**PROPOSED GREEN FUEL STATION (ELECTRIC VEHICLE CHARGING) AND SHOP AND  
SERVICES (CONVENIENCE STORE) AT WORKSHOPS 7 & 8 ON GROUND FLOOR,  
METRO CENTRE, 32 LAM HING STREET, KOWLOON BAY, KOWLOON**

**Planning Application No. A/K13/334 – Further Information (5)**

**Consolidated Report**

**Attachment 1: Response-to-Comment Table (Departmental Comments)**

1:250 in A4

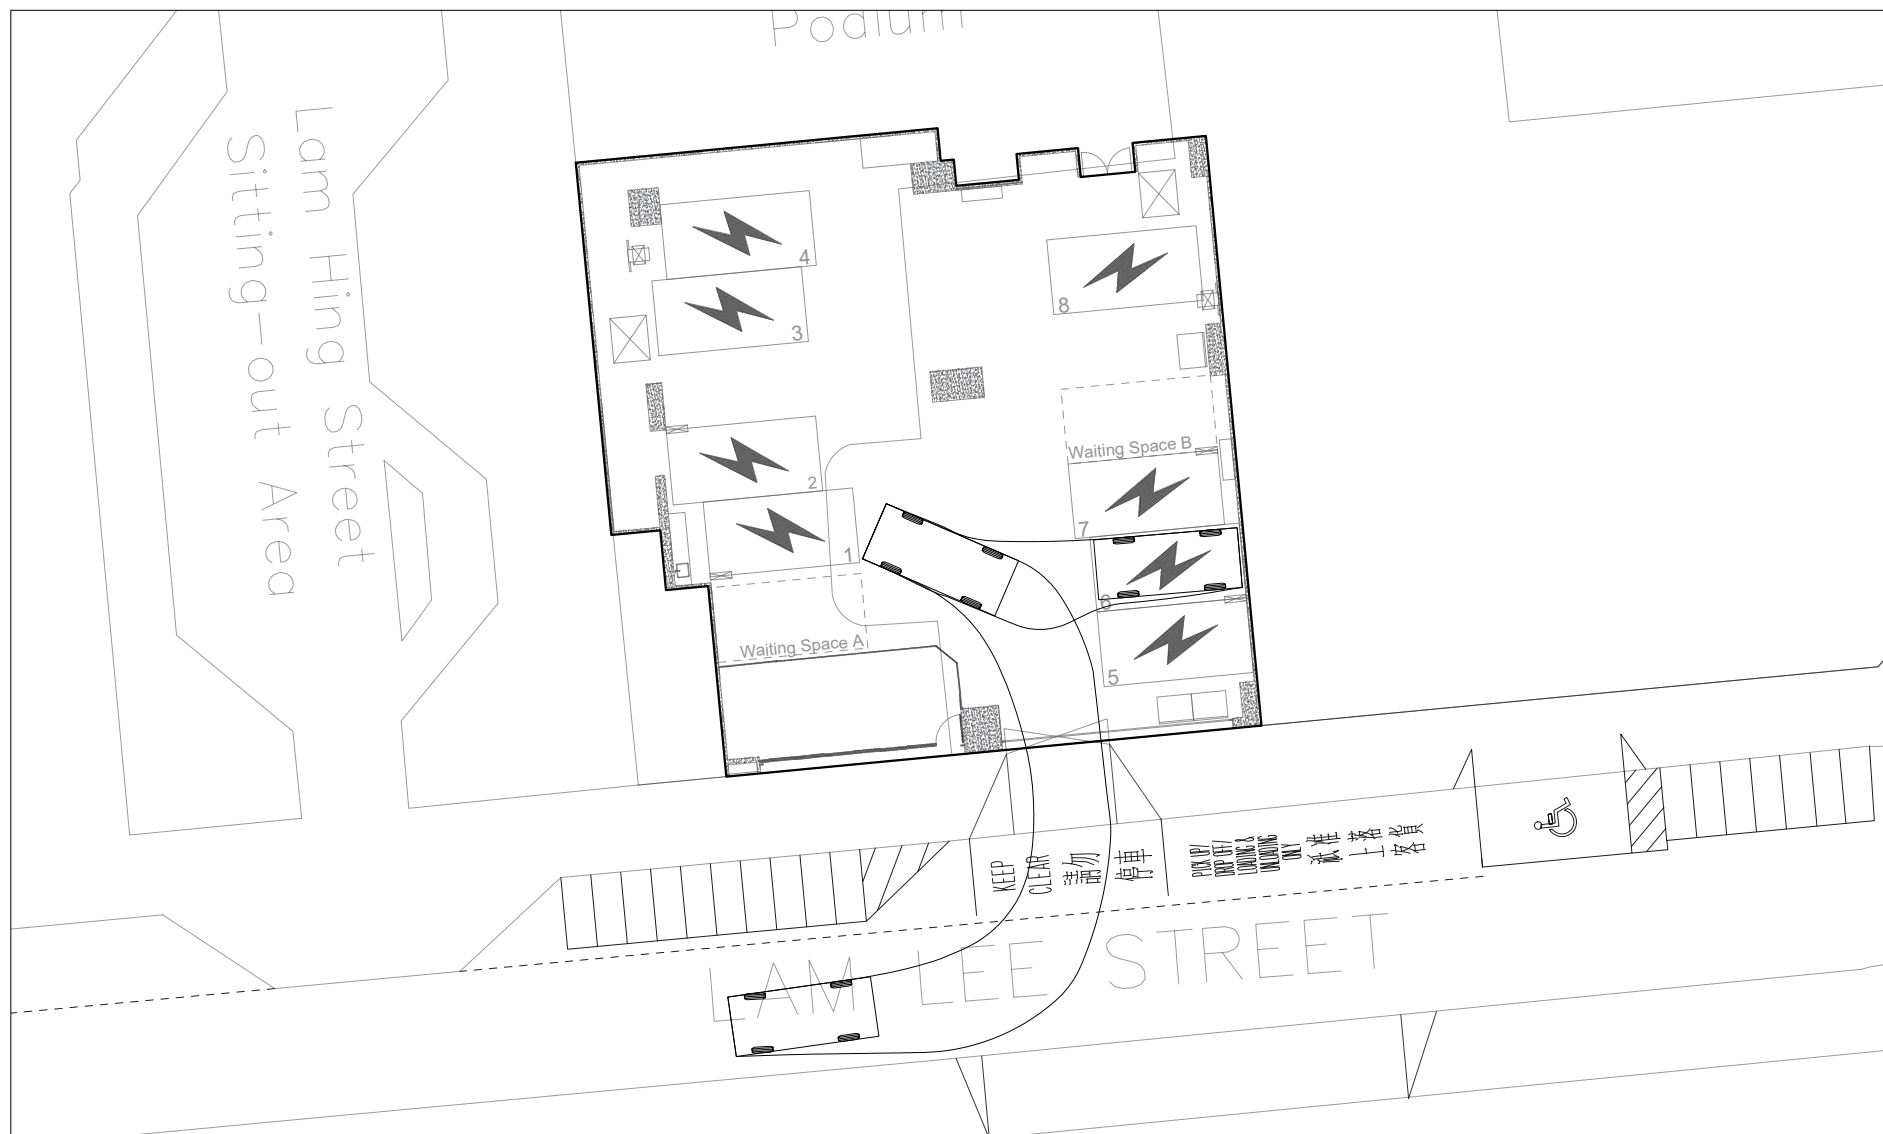
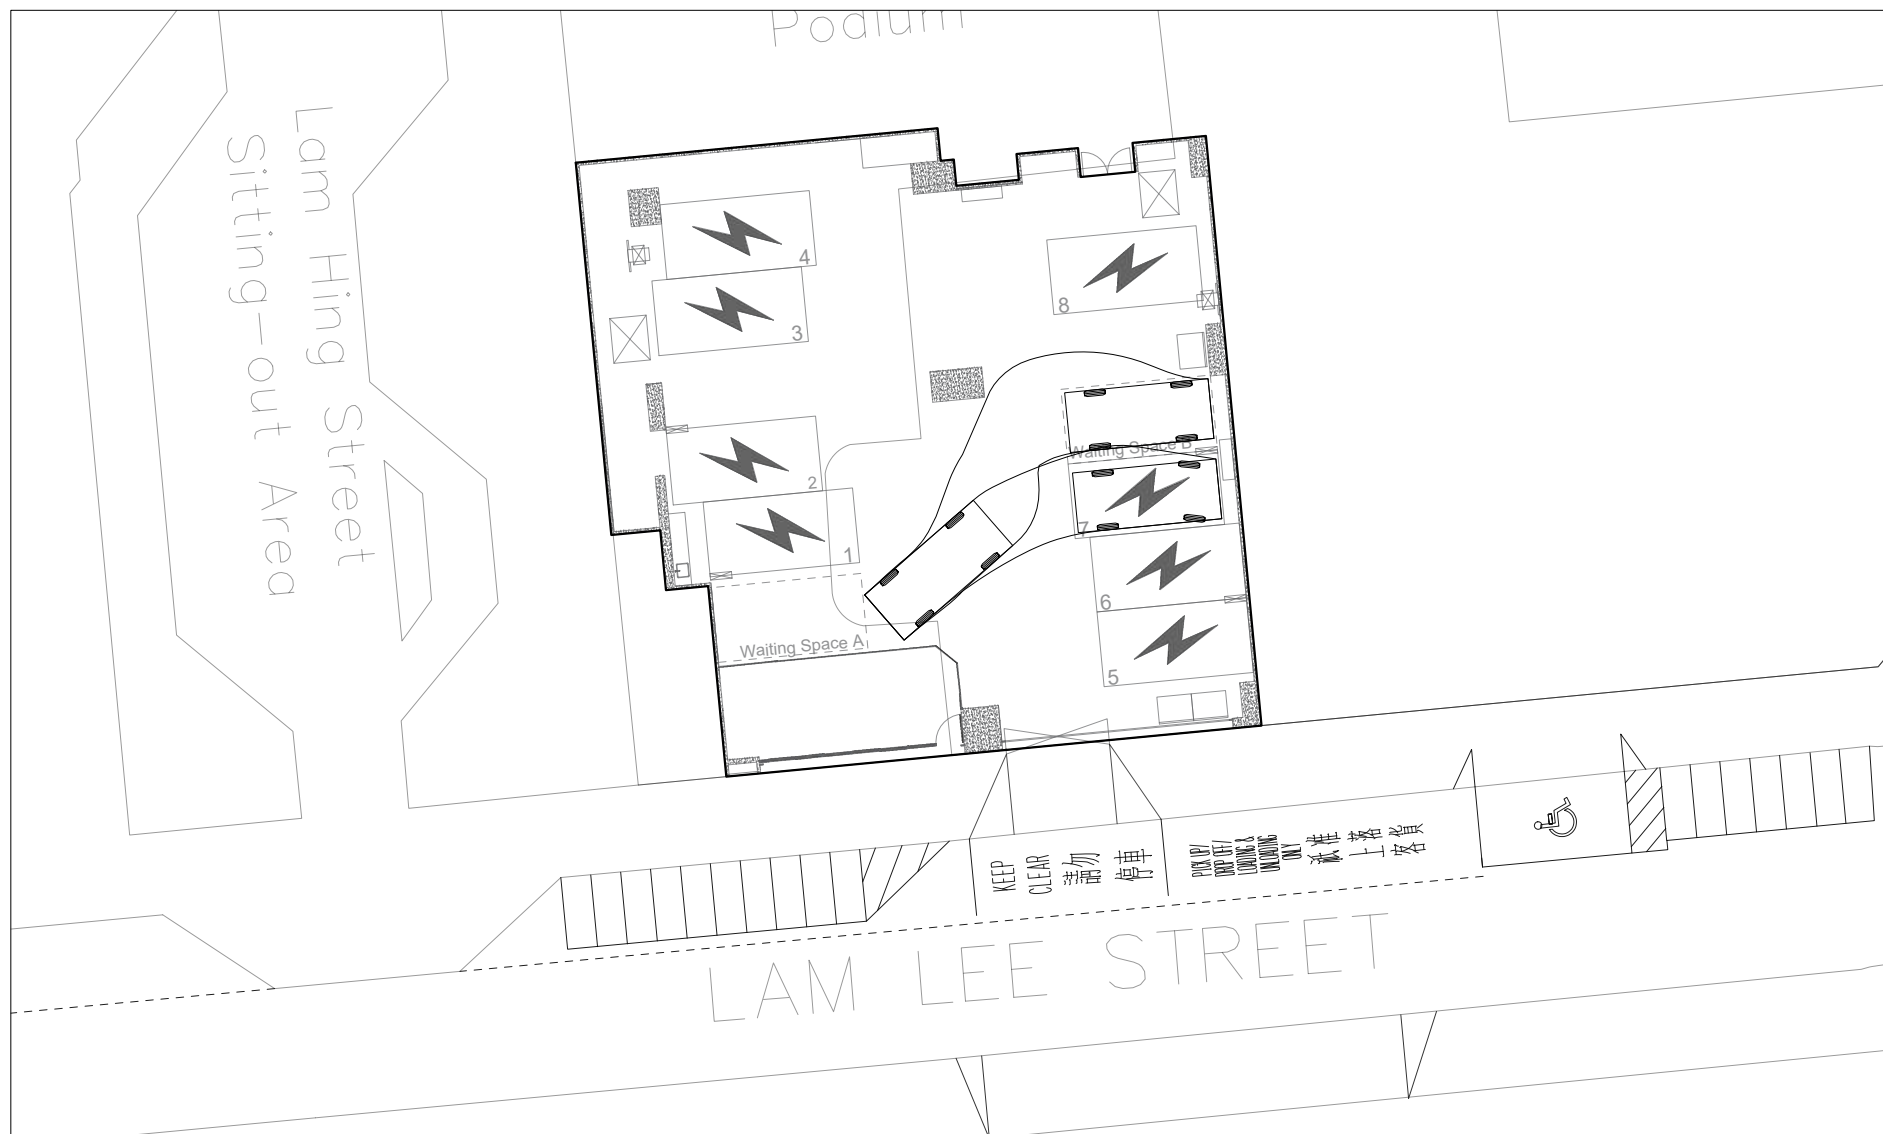
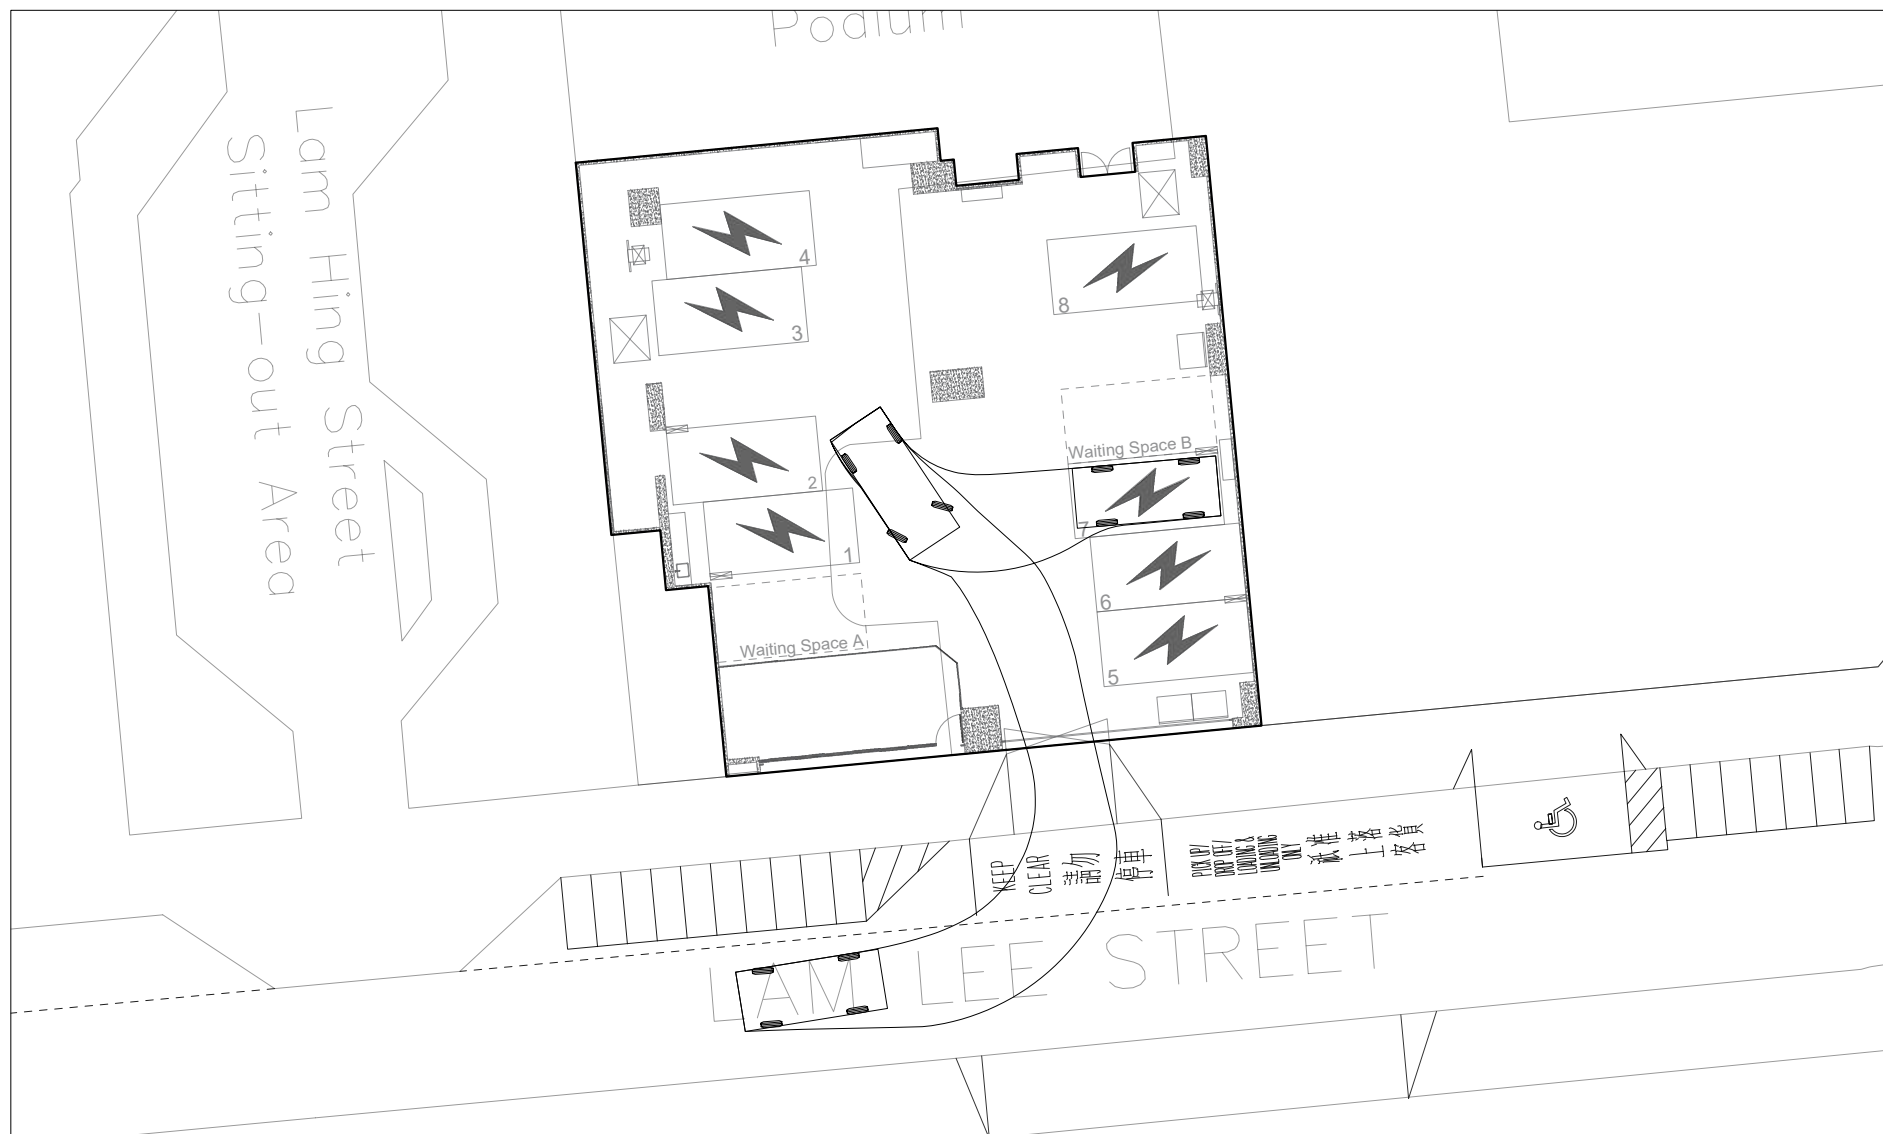
| <i>Departmental Comments</i>                                                                                                                                                                                                                                                                                                                                                                                                                                                                                                                                                                                                                                                                                                                                       | <i>Response</i>                                                                                                                                            |
|--------------------------------------------------------------------------------------------------------------------------------------------------------------------------------------------------------------------------------------------------------------------------------------------------------------------------------------------------------------------------------------------------------------------------------------------------------------------------------------------------------------------------------------------------------------------------------------------------------------------------------------------------------------------------------------------------------------------------------------------------------------------|------------------------------------------------------------------------------------------------------------------------------------------------------------|
| 1. The swept path analyses of the vehicle entering and leaving the EV charging spaces No. 1, 3, 6, 7 and 8 as well as the waiting spaces No. 1 and 2 are missing. Please provide those swept path analyses for further review.                                                                                                                                                                                                                                                                                                                                                                                                                                                                                                                                     | Please refer to <b>Appendix A of Attachment 2 – Revised Traffic Review Report</b> for the swept path analyses of all charging spaces and waiting spaces.   |
| 2. The backward movement of vehicles on the public road for entering the EV charging space No. 2 of the Premises was noted based on the swept path analyses as enclosed in Appendix A of the Traffic Review Report. We do not support it from traffic engineering perspective, which such backward movement of vehicles on the public road for entering the Premises may pose potential danger and raise road safety issues to the road users. Please review and revise the swept path analyses, and also                                                                                                                                                                                                                                                          | Noted. Please refer to <b>Figure 3 in Appendix A of Attachment 2 (p.25)</b> , showing the revised swept path of the vehicle entering charging space No. 2. |

| <i>Departmental Comments</i>                                                                                                                                                                                                                                                                                                                                                                                                                                                                                                                                                                                                                                                                                                                                                                                                                                                                                                                                                                                                                                                        | <i>Response</i>                                                                                                                                               |
|-------------------------------------------------------------------------------------------------------------------------------------------------------------------------------------------------------------------------------------------------------------------------------------------------------------------------------------------------------------------------------------------------------------------------------------------------------------------------------------------------------------------------------------------------------------------------------------------------------------------------------------------------------------------------------------------------------------------------------------------------------------------------------------------------------------------------------------------------------------------------------------------------------------------------------------------------------------------------------------------------------------------------------------------------------------------------------------|---------------------------------------------------------------------------------------------------------------------------------------------------------------|
| 2. As referring to the swept path analyses in the revised traffic review report, it is noted that reverse movement of the private car from the public road to the captioned EV charging station would not be required. However, it only shows the swept path of the private car from the waiting space A to the charging space no. 8 as well as the swept path of the private car from the waiting space B to the charging space no. 1. Please supplement the swept path analyses of the private car from the waiting space A to all the other charging spaces. Similarly, please supplement the swept path analyses of the private car from the waiting space B to all the other charging spaces. Please be noted that the drivers would wait at the waiting spaces once all the charging spaces in the EV charging station are full. Once the charging space is available, the driver at the waiting space should be able to access the vacant charging space (i.e. can be any of the charging space no. 1 to 8) without requiring to have reverse movement onto the public road. | Noted. Please refer to the revised swept path analyses in <b>Attachment 2</b> for your reference.                                                             |
